LEYLAND-TRIUMPH SALES COMPANY, INC.

TO: ALL TRIUMPH DEALERS - WESTERN ZONE

DEPT: SERVICE DEPARTMENT

SUBJECT: TRIUMPH HERALD, TRIUMPH 1200
AND SPITFIRE - GENERATOR
REINFORCING BRACKET

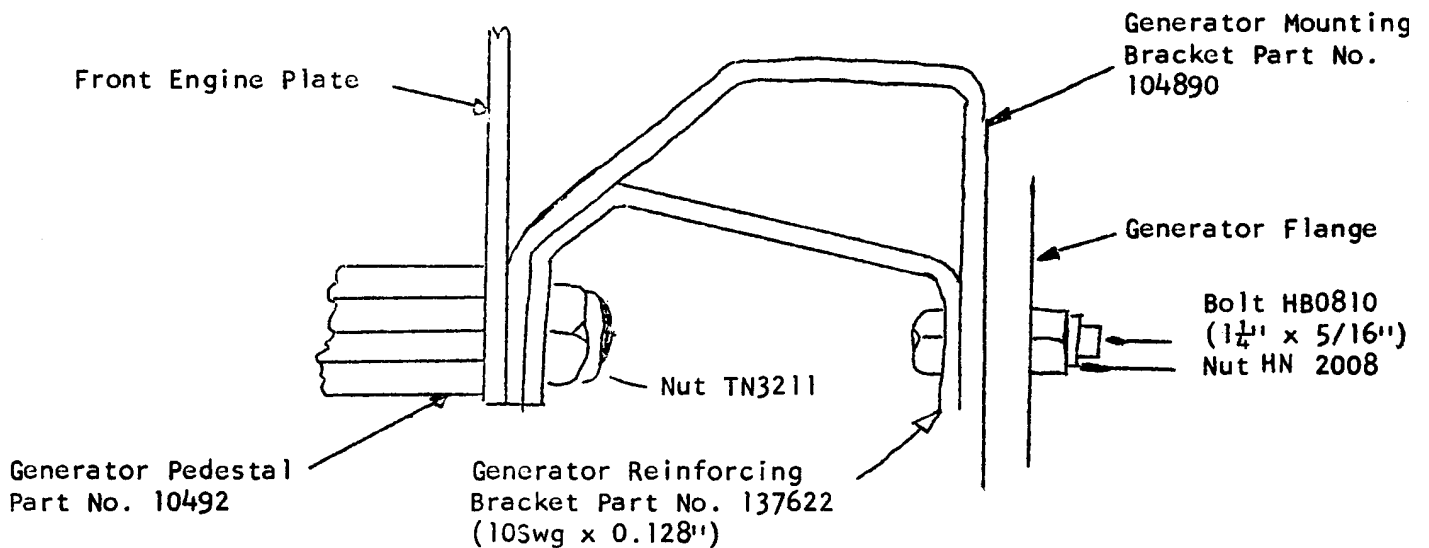
Should a failure of the generator mounting bracket occur on any of the above models, the bracket should be replaced by the following details which include an additional reinforcing bracket.

The diagram shown below illustrates the location of the additional reinforcing bracket.

Generator mounting bracket	104890	1 off
Generator reinforcing bracket	137622	1 off
Generator bolt	HB0810	1 off
Generator bolt nut	HN2008	1 off

SCHEME SHOWING CALIPER PISTON AND ALSO CORRECT POSITION OF DISC PADS TO OVERCOME SQUEALING.

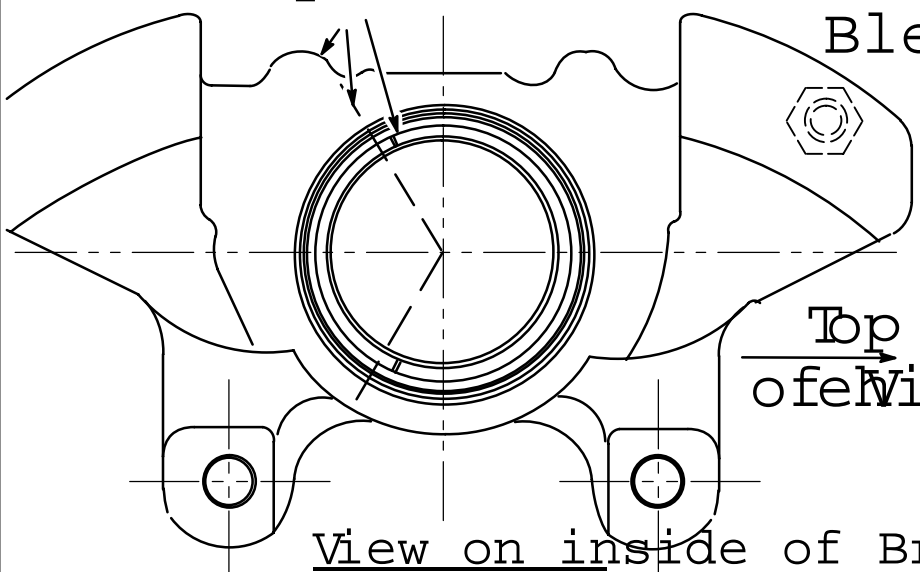
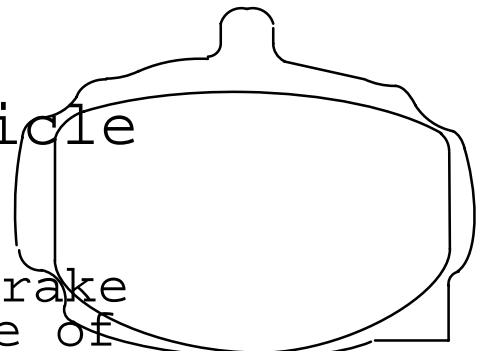
For correction of brake squealing the following procedures will usually prove to be effective.

1. Ensure that the pads are fitted correctly, with the edge "A", arrowed in the illustration, at the top of the caliper "B". This should be checked on any car, as at some earlier date, the pads may have been removed for some purpose and refitted incorrectly.
2. Whilst pads are removed, discard the claw type shim.
3. Before refitting pads, reset the four caliper pistons to bring the undercut section to the position illustrated "C".

Piston to be positioned with the step in top position relative to casting as shown

Disc pad to the Inside with the Edge on the Same Side as the Bleed Screw

SUBJECT: SPECIAL SAFETY CHECK
CAMPAIGN - BRAKE PIPE
FOR IMMEDIATE AND URGENT ACTION

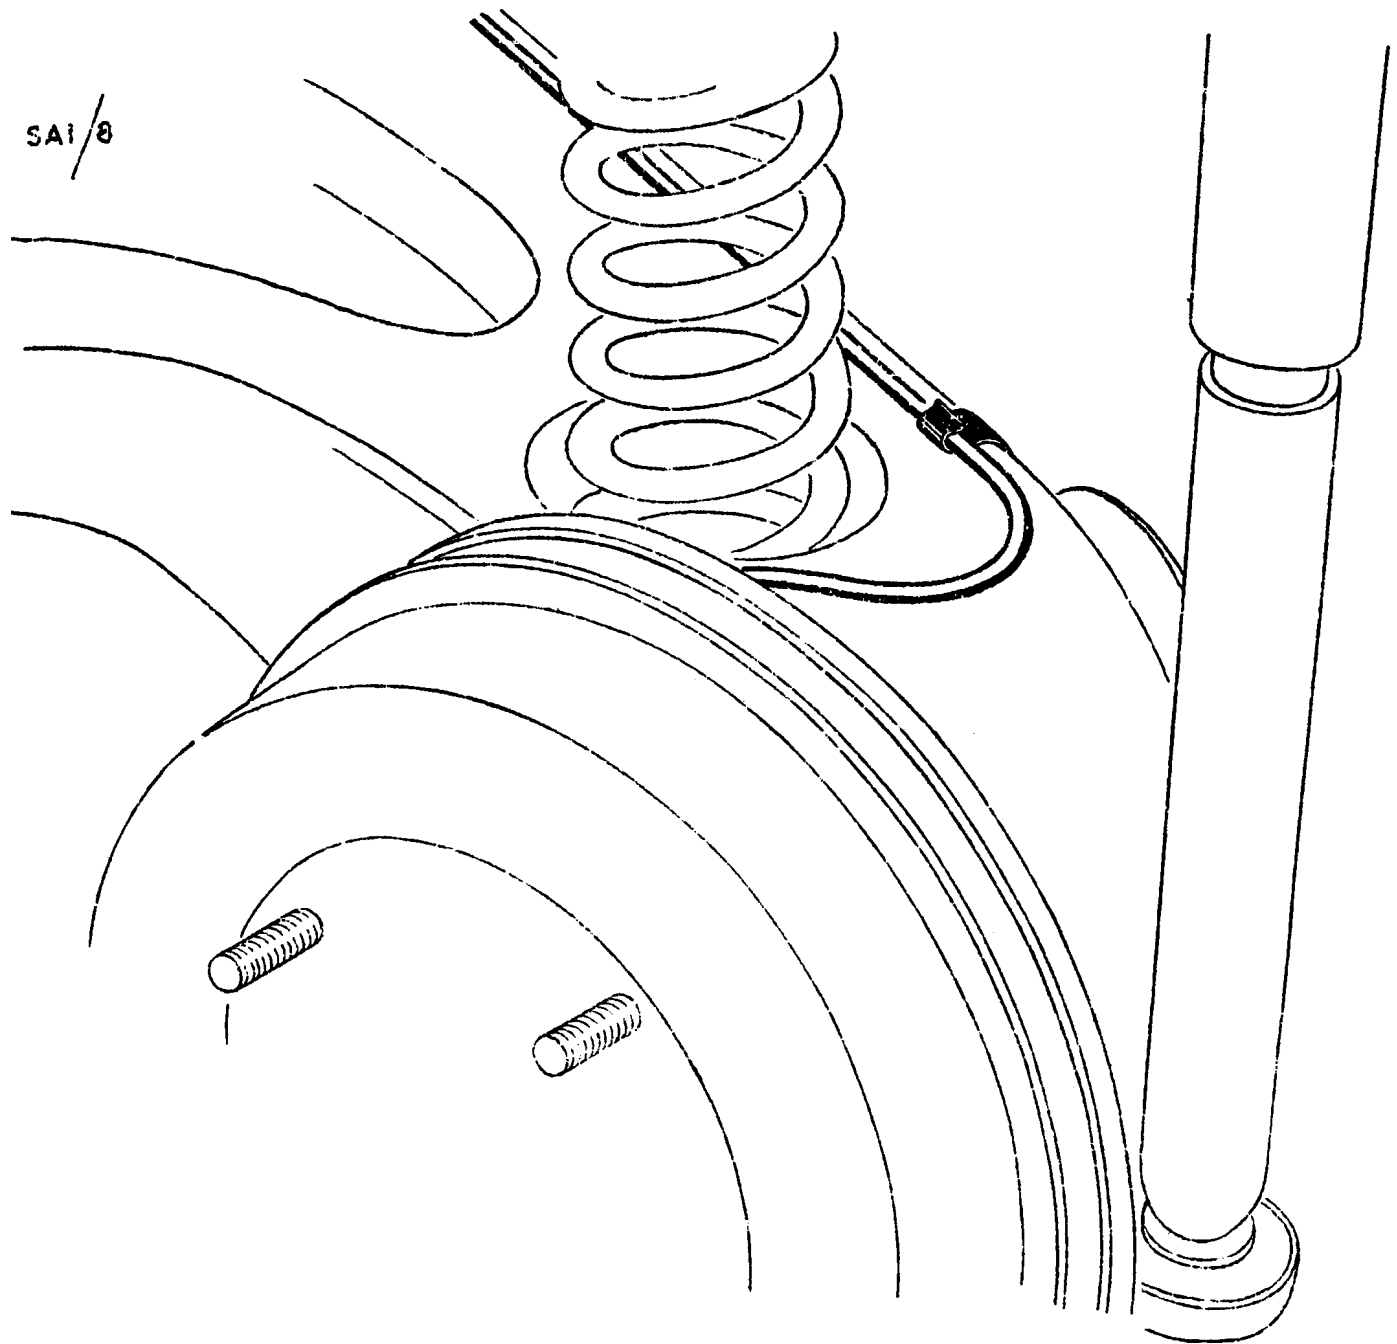
All Triumph 2000 cars sold through your organization should be called in immediately for the position of the brake pipes on the trailing arms to be examined to ensure that they have adequate clearance from the coil spring.

An illustration showing the location of the pipe and the position of the clip is attached.

Pipes should be reset where the clearance is less than 1" and if damaged should be replaced.
